STATE OF NORTH CAROLINA
DEPARTMENT OF TRANSPORTATION

Subject: **Application for Modification of the Section 404 Individual Permit, Section 401 Water Quality Certification, and Riparian Buffer Certification** for the Continuation of Greensboro-High Point Road (SR 4121) on New Location in Guilford County, Federal Aid Project No. STP-4121(1), Division 7, TIP No. U-2412 A, Debit \$570 from WBS 34802.1.1.

**Minutes from the Interagency 4C Permit Drawing Review Meeting
U-2412A in Guilford County
September 21, 2017
NCDOT Century Center
10:00 AM – 12:00 PM**

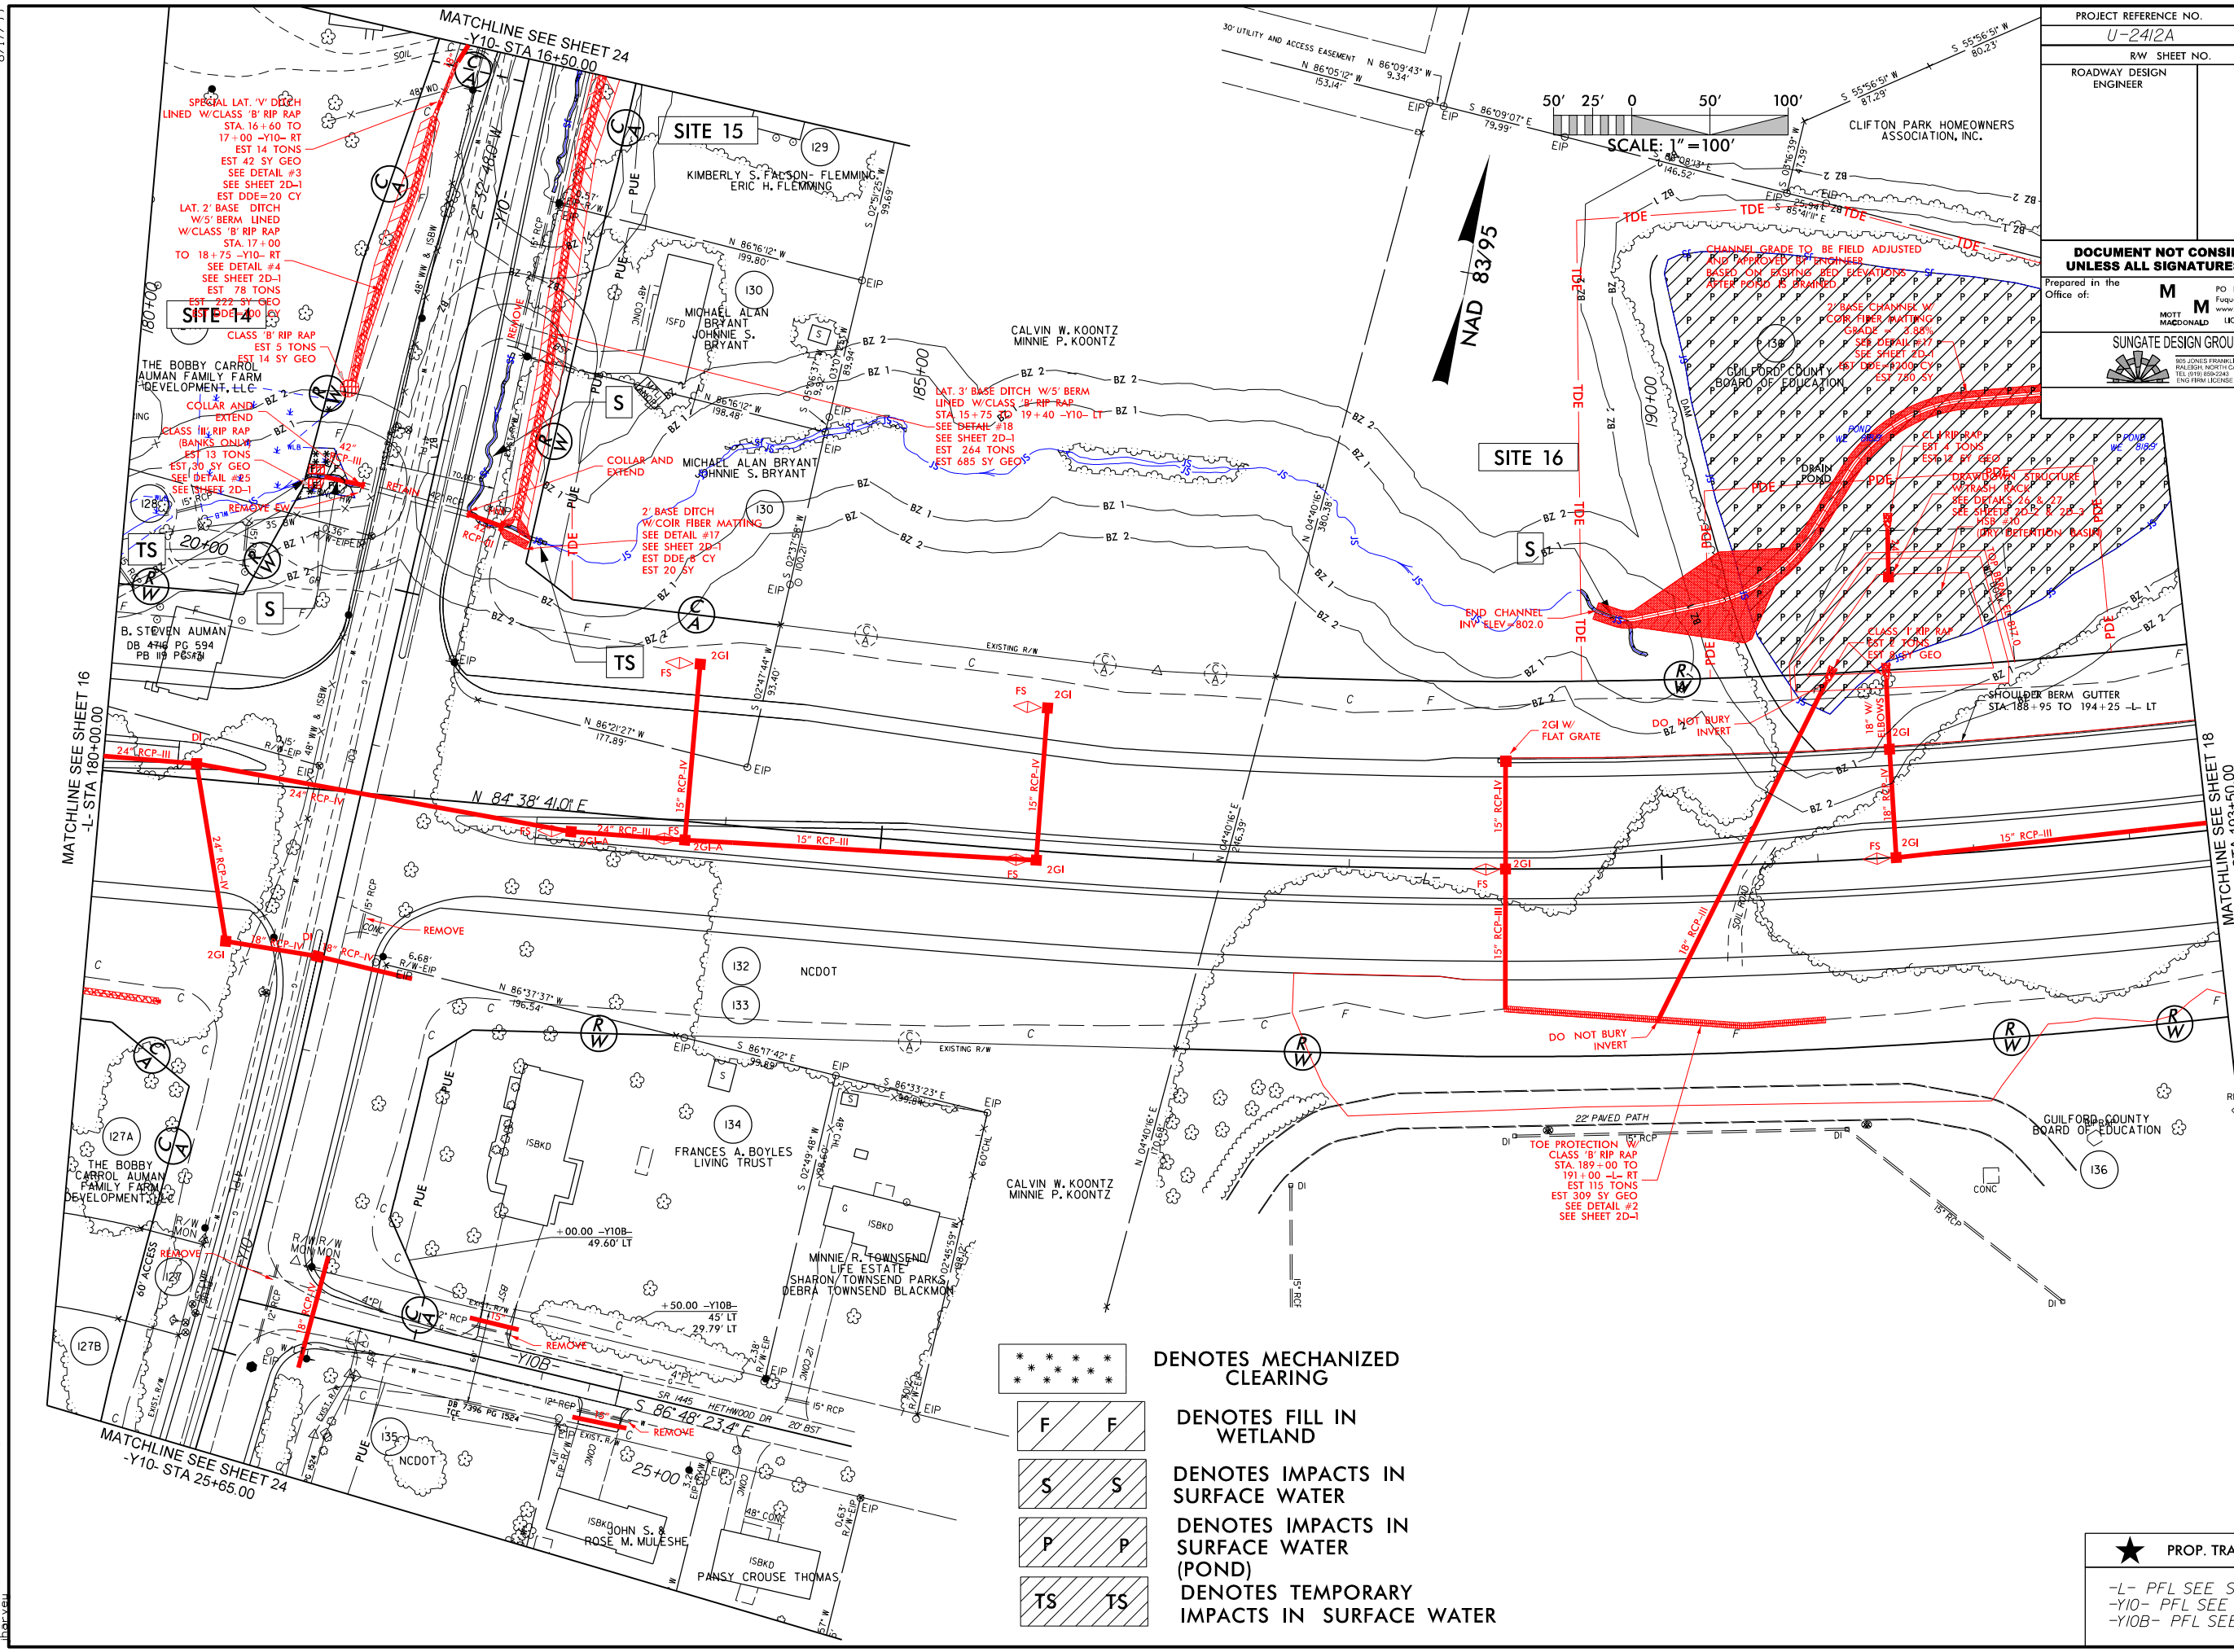
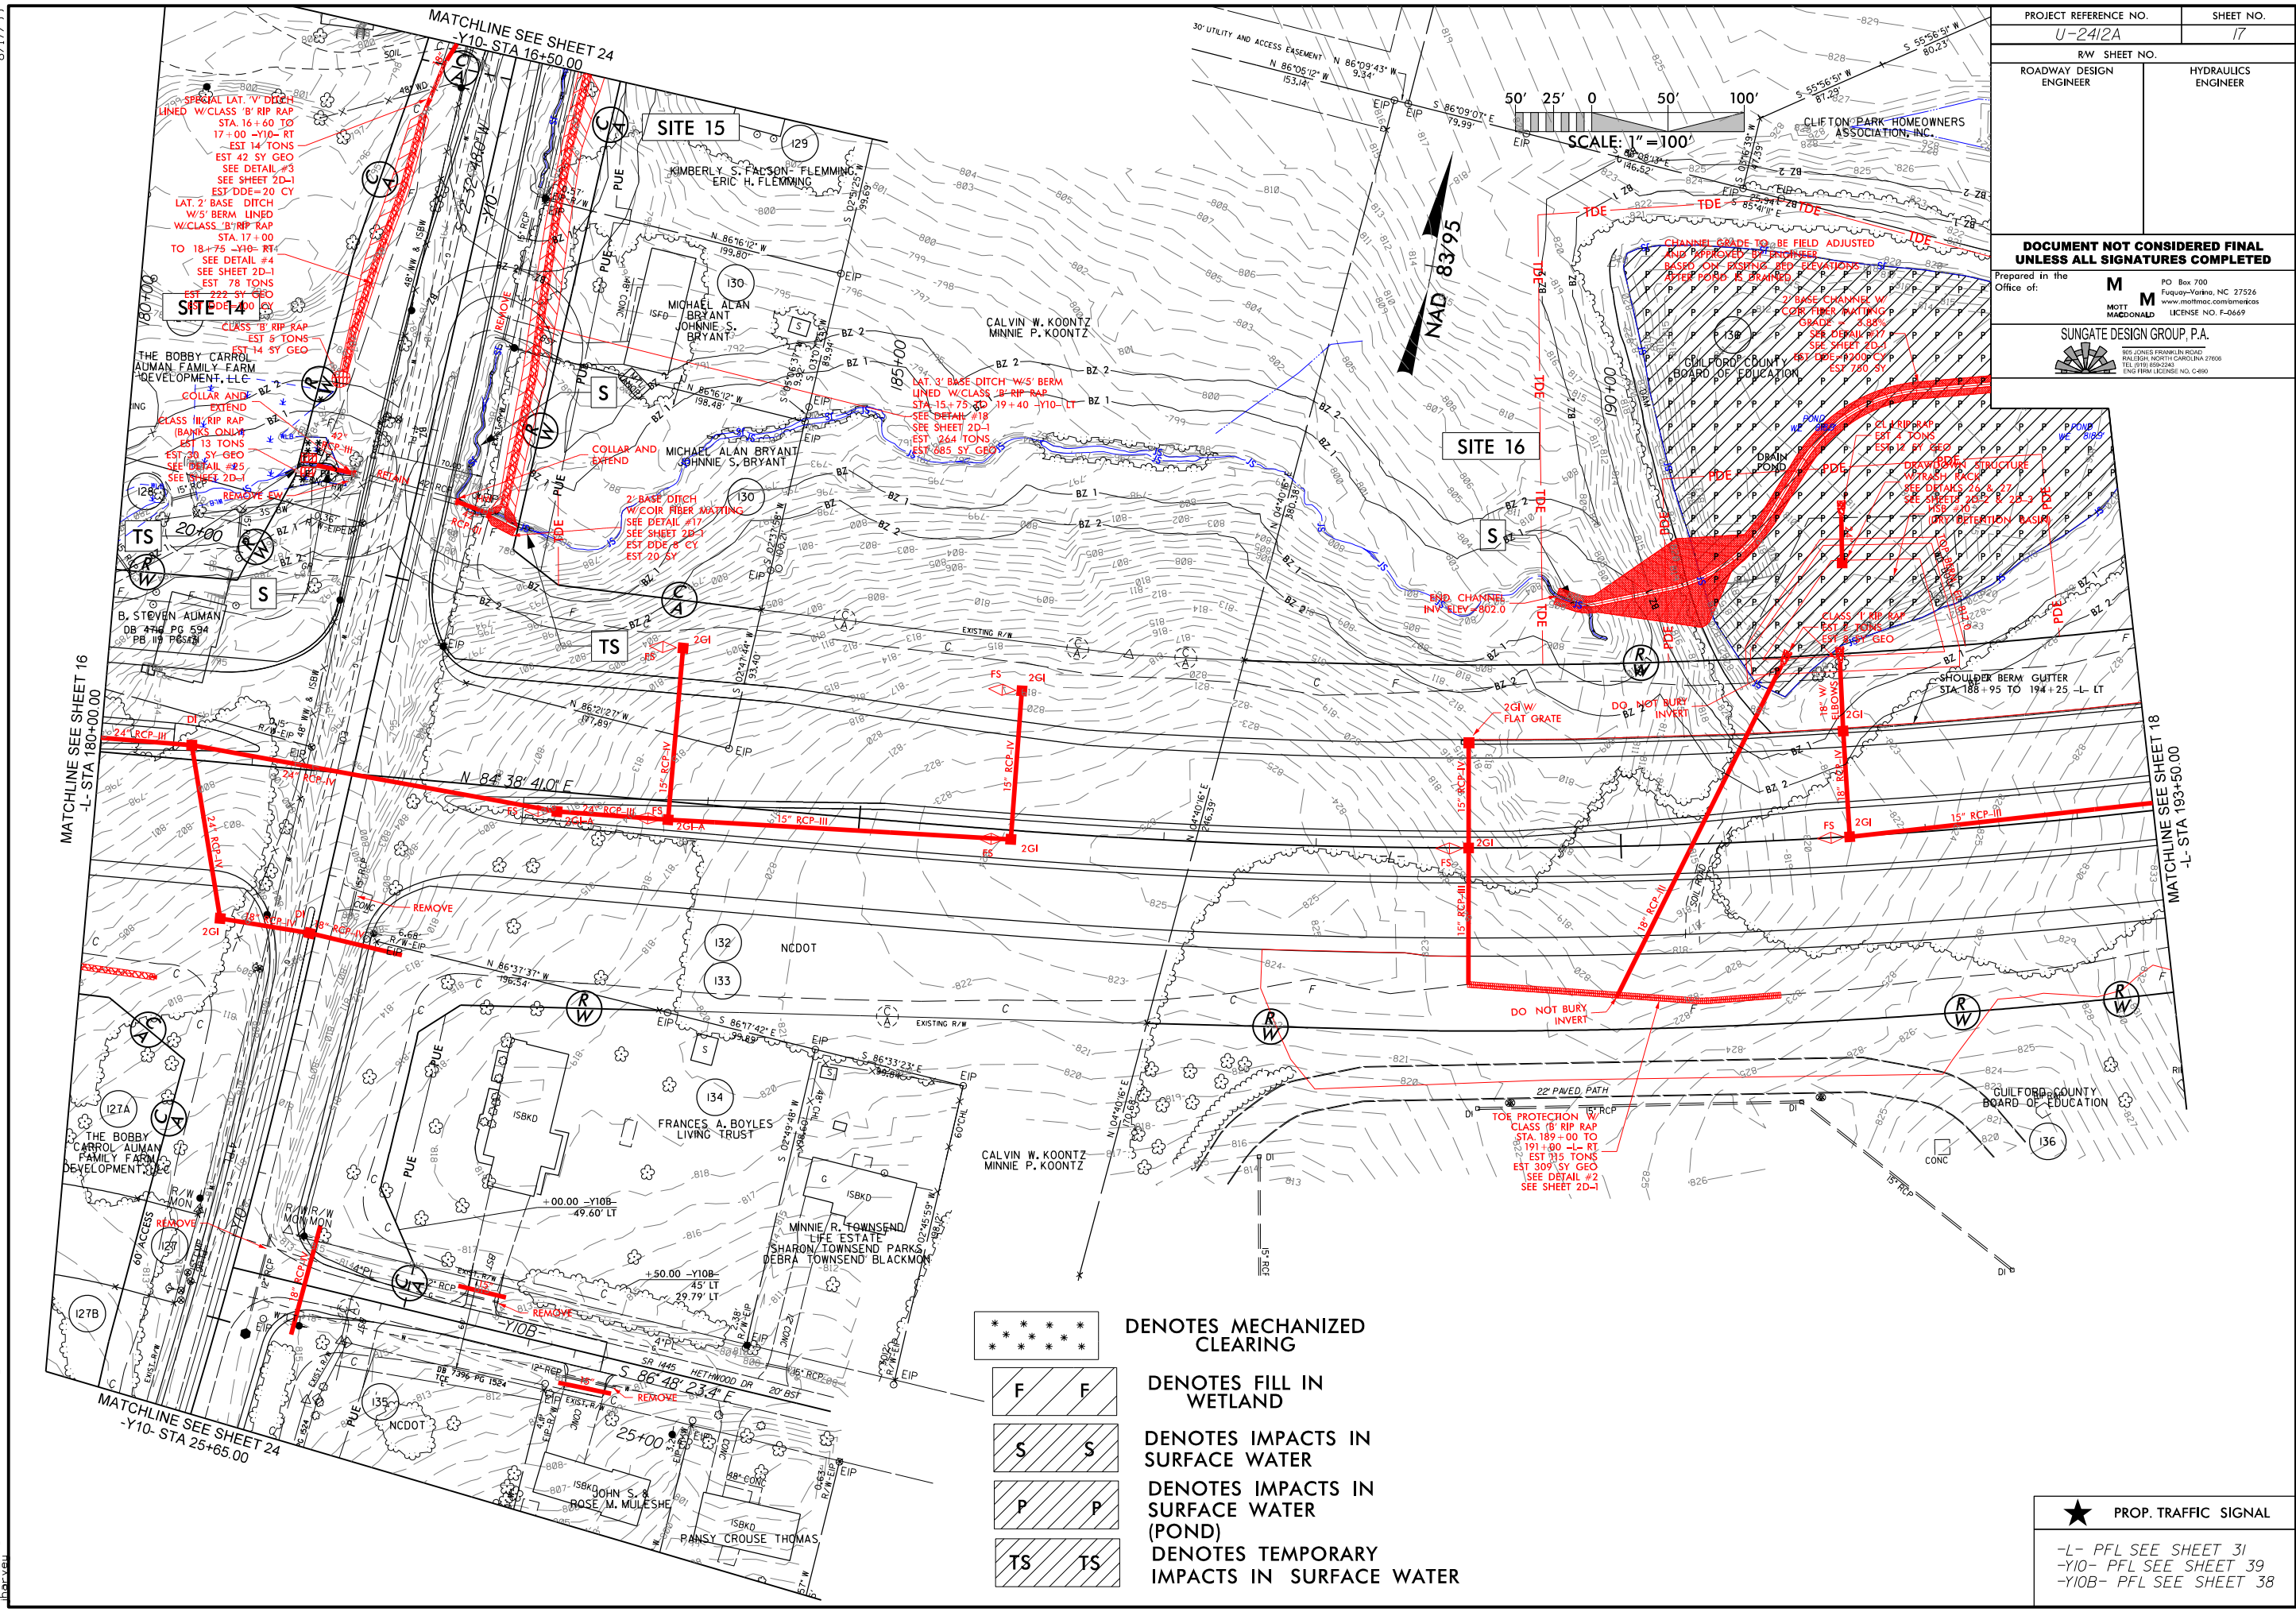
Site 14 (Plan Sheet 17):

- Add note to impact summary "Sites 13 & 14 on same JS".

Site 15 (Plan Sheet 17):

- The ROW adjacent to Parcels 129 (Bryant) & 130 (Flemming) is currently shown as Controlled Access. The Division (Patty Eason) will investigate if the ROW should be revised to all Partial Controlled Access. Driveway pipes will need to be added if access is allowed.
- Corps to investigate status of the JS. It was shown as intermittent on 2017 JD.
